RE: Council File 13-0509
CPC-2011-2103-VZC-HD-ZAA
320 N. La Cienega

To: Beverly Grossman Palmer – Strumwasser & Woocher LLP
From: Sean Daly, PTP
Date: May 10, 2013
Re: Proposed 320 N. La Cienega Mixed-Use Development Traffic Impact Study Review

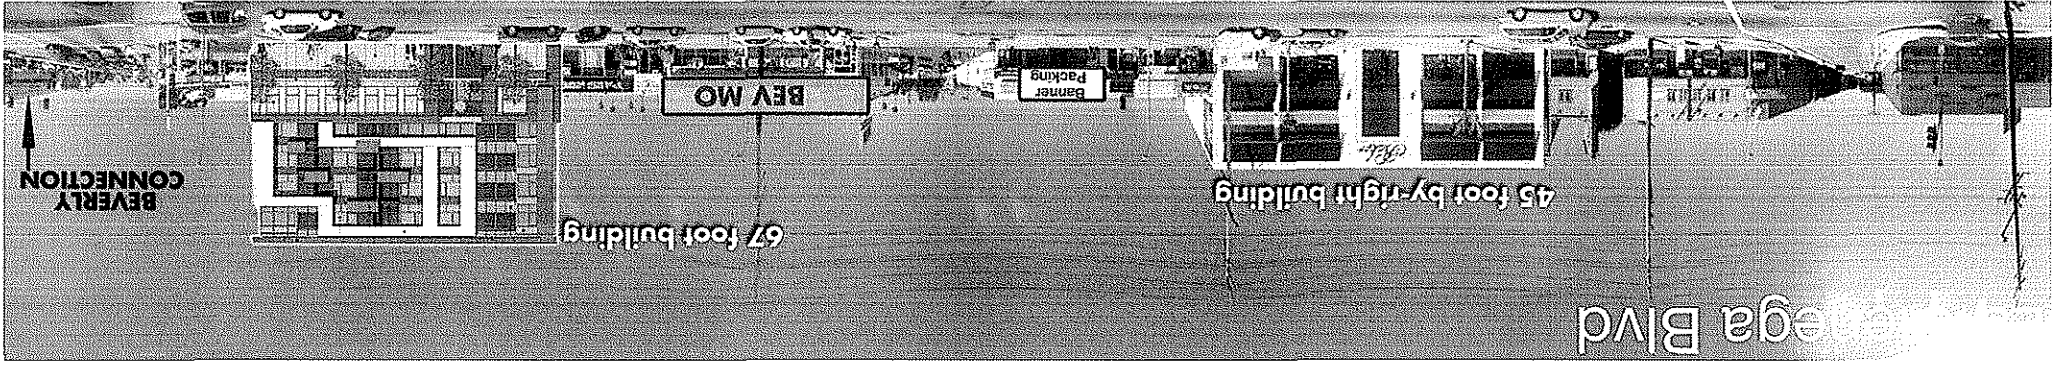
45 feet is the height limit allowed by the Wilshire Plan

45 foot by-right building
